UNITED STATES
NUCLEAR REGULATORY COMMISSION

MEMORANDUM FOR: Docket File No. 40-8907

SUBJECT: AMENDMENT NO. 10 TO SOURCE MATERIAL LICENSE SUA-1475 FOR
 RECLAMATION AND CLOSURE OF THE UNITED NUCLEAR
 CORPORATION (UNC) CHURCH ROCK MILL NEAR GALLUP, NEW MEXICO

Figure 3

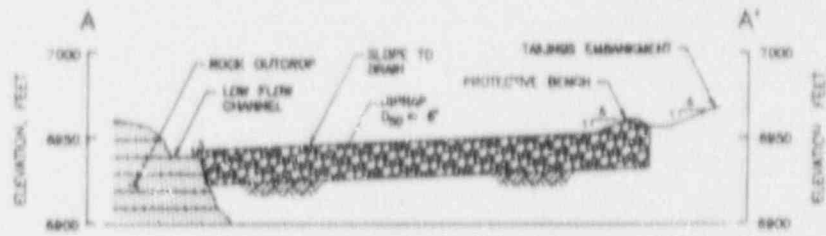
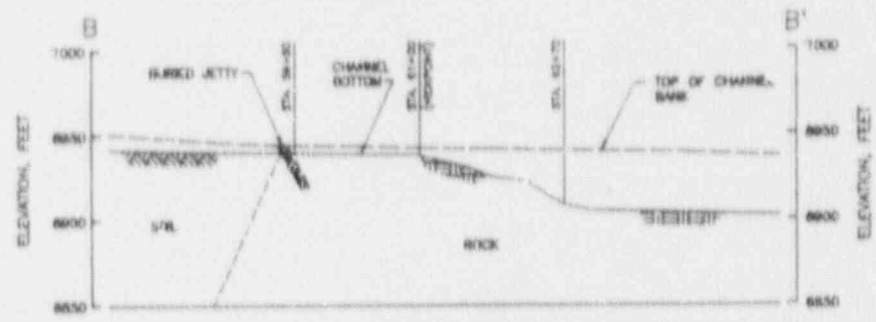
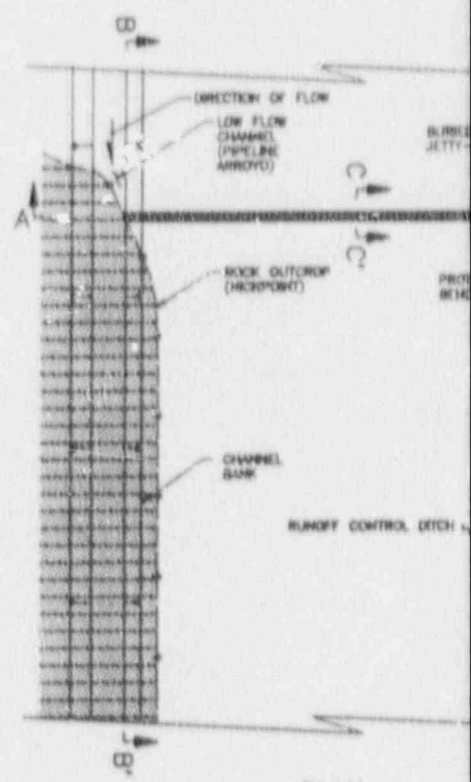
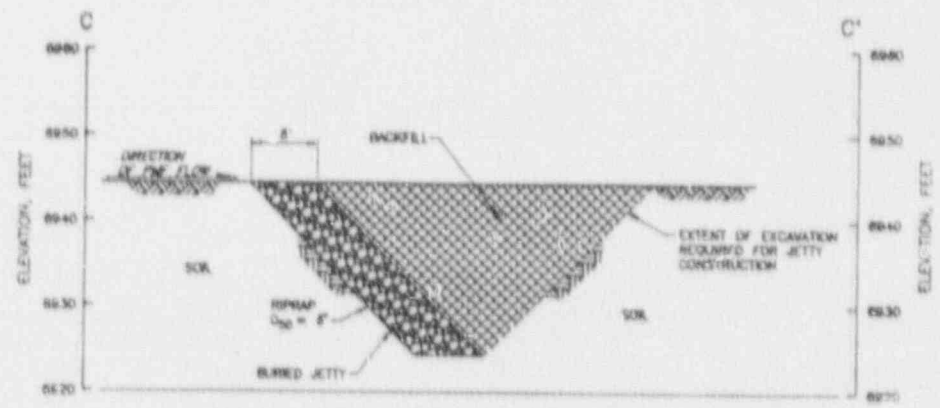
As shown in Figures 2 and 3, UNC's proposed reclamation plan consists of stabilizing the tailings in place. The tailings will be graded to allow positive drainage off the pile top. A soil cover will then be placed over the tailings to limit radon emanation to acceptable levels. To protect against erosion, a soil/rock layer will be placed over the radon soil cover. The pile top slopes will vary from less than one percent to about four percent. To minimize the potential for erosion of the pile top, wide gently sloping swales will be placed perpendicular to the slopes to limit runoff distances. These swales will be lined with riprap. The embankment out slopes will be flattened to 20 percent (5H:1V) and erosion protection will be provided by a layer of riprap.

The PMF water surface elevations in Pipeline Arroyo will be below the top of the proposed protective bench. Thus the bench will protect the toe of the tailings dam embankment and the runoff control ditch will be above the PMF level. (See Figure 4 for a typical section of Pipeline Arroyo showing the PMF water level in relation to the protective bench and runoff control ditch). The average velocities and depths of the PMF along the 5H:1V sideslopes of the protective bench were determined by the licensee using the HEC-2 computer program. The results of this analysis indicated that during a PMF event, a maximum average velocity of 6.4 feet per second would occur at station 57+75. To determine the amount of scour that would take place during the PMF the licensee used methods described by the Bureau of Reclamation (Pemberton and Lara, 1984). This evaluation indicated that the maximum lateral erosion to be expected would be less than five feet. As shown on Figure 4, the runoff control ditch is located 14 feet from the protective bench and the toe of the tailings embankment is 40 feet away. Thus the licensee concluded that the protective bench will provide adequate protection to the tailings pile.

Figure 5

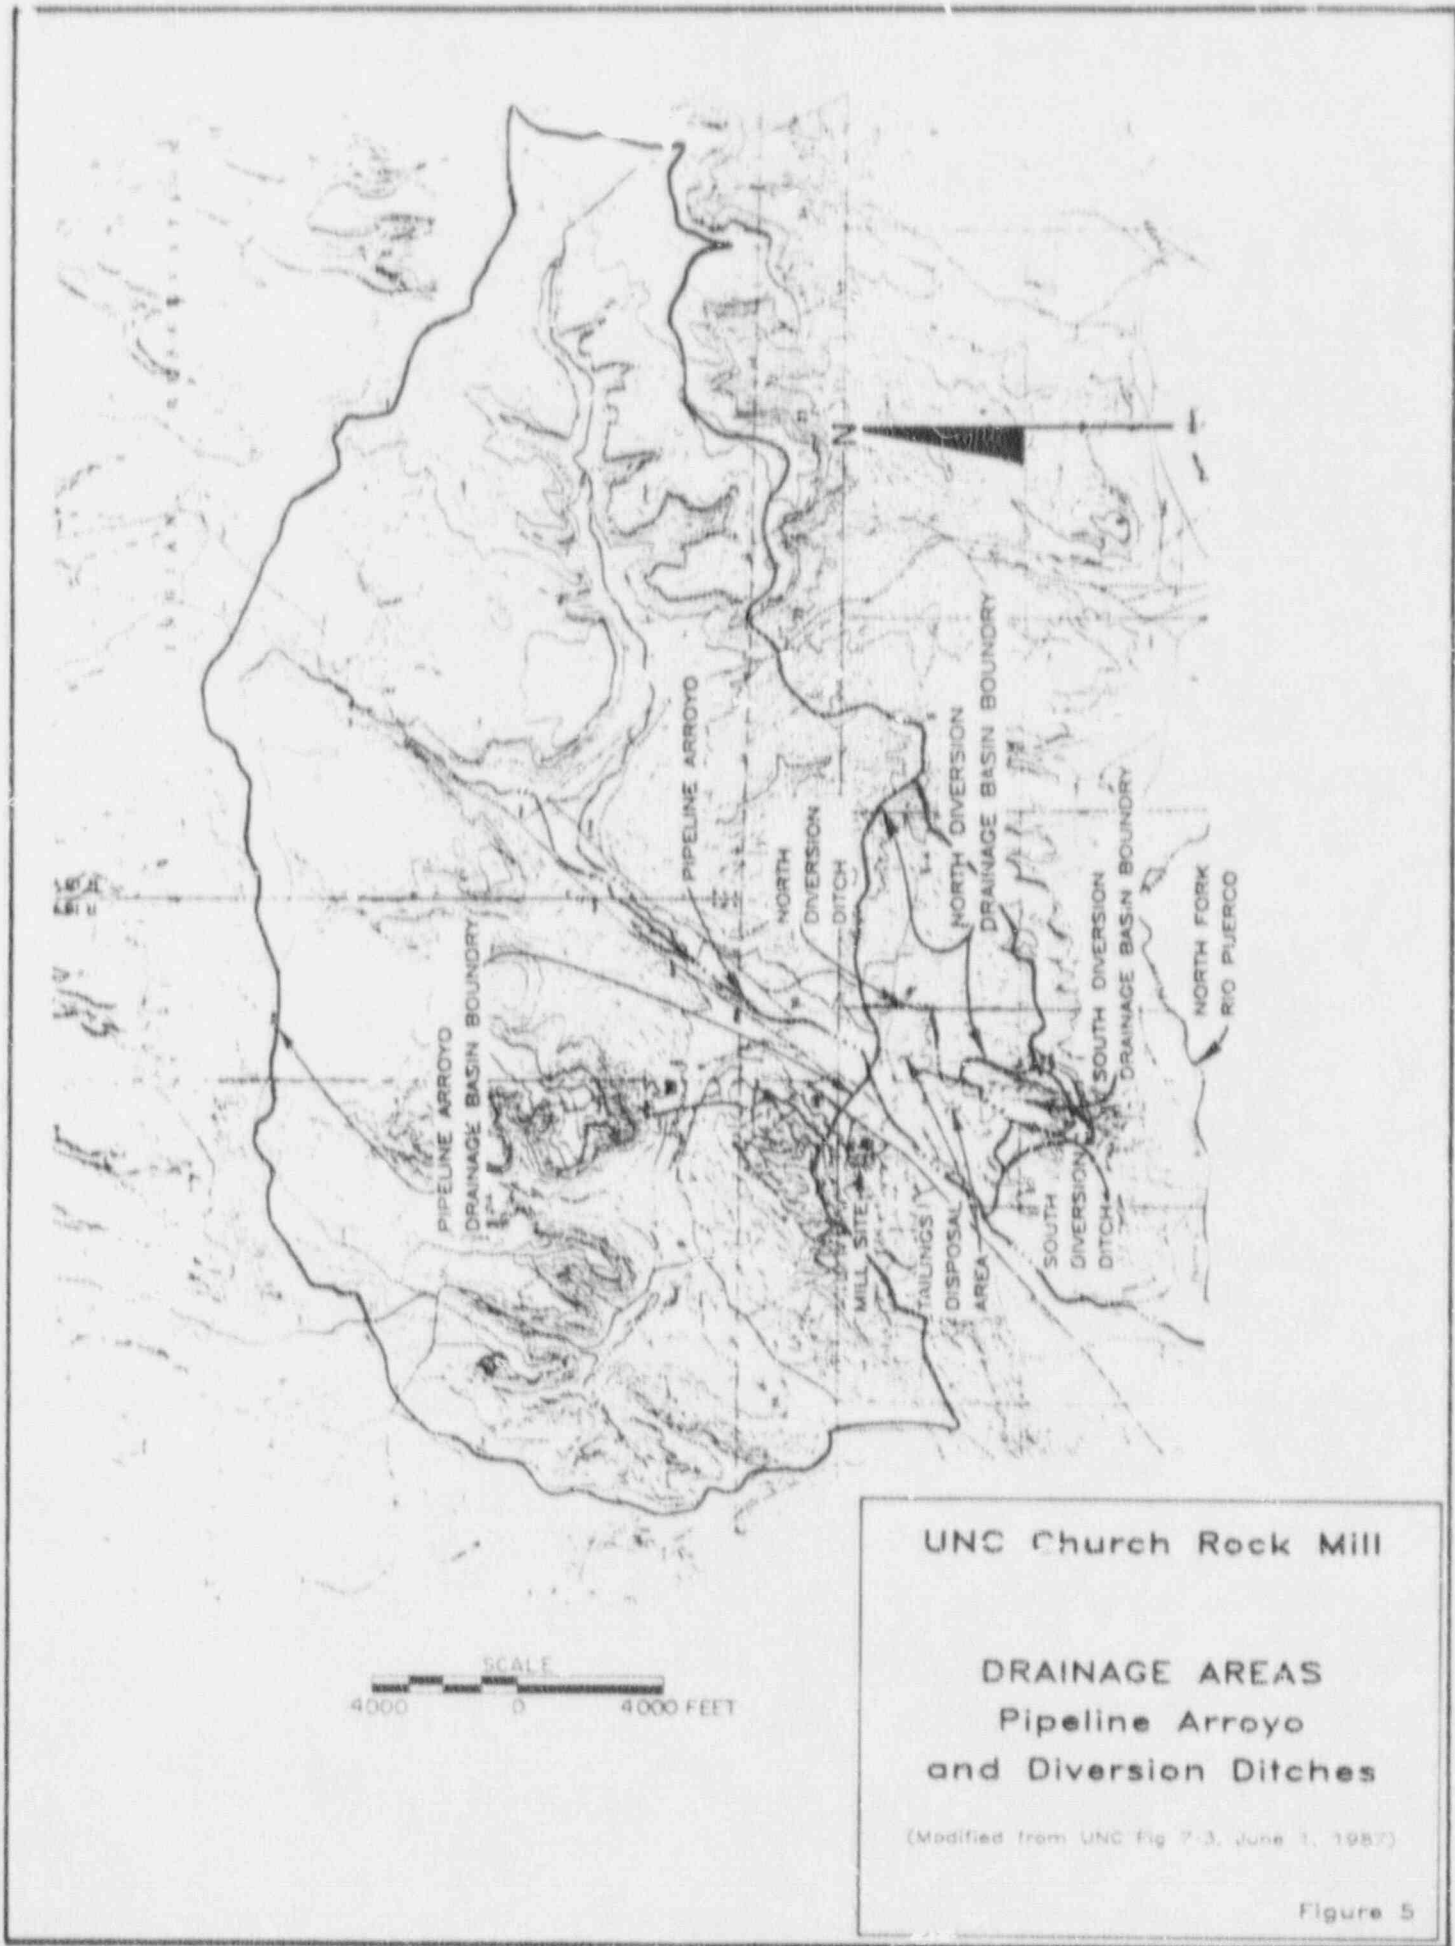
The Church Rock Mill and disposal areas are located at elevations ranging from about 6950 to 7000 feet above mean sea level within the drainage area of Pipeline Arroyo. As shown on Figure 1, Pipeline Arroyo is an ephemeral channel that flows from northeast to southwest along the western edge of the disposal area to a point about 2.5 miles southwest of the mill site where it joins the Rio Puerco. The drainage area of Pipeline Arroyo upstream of the disposal area is about 17 square miles (See Figure 5).

As shown on Figure 5, the North Diversion Ditch will intercept flows from a small drainage area east of the tailings pile. The ditch is an existing structure having a relatively uniform channel gradient of approximately 0.0075. Using Manning's equation the licensee estimated that during a PMF, velocities in the North Diversion Ditch will average between 9 and 18 fps. Velocities of this magnitude are considered to be erosive. However, since tailings are located at least 300 feet from the North Diversion Ditch, the licensee concluded that erosion protection is not required. Based on a review of the licensee's calculations and an independent calculation, the staff concluded that the licensee's estimates of velocities in the North Diversion Ditch are conservative. However, it was concluded that erosion protection is required at two locations along the ditch where erosion along the outside banks of curves in the ditch could potentially affect tailings. In response, the licensee

The South Diversion Ditch also intercepts flood flows from a small drainage area to the east as shown in Figure 5. The ditch is an existing structure, generally trapezoidal in shape with a 15-foot bottom and 2H:1V side slopes. The average gradient is about 0.003. Using Manning's equation the licensee determined that the ditch is capable of conveying the PMF with sufficient freeboard and thus no modification to the ditch is required. The licensee did not provide flow velocity estimates for the South Diversion Ditch so an independent calculation was made. This calculation indicated a maximum average velocity of about 6 fps. This velocity is marginally erosion. However, since the ditch is at least 500 feet from tailings, it is concluded that erosion protection is not required for the South Diversion Ditch.
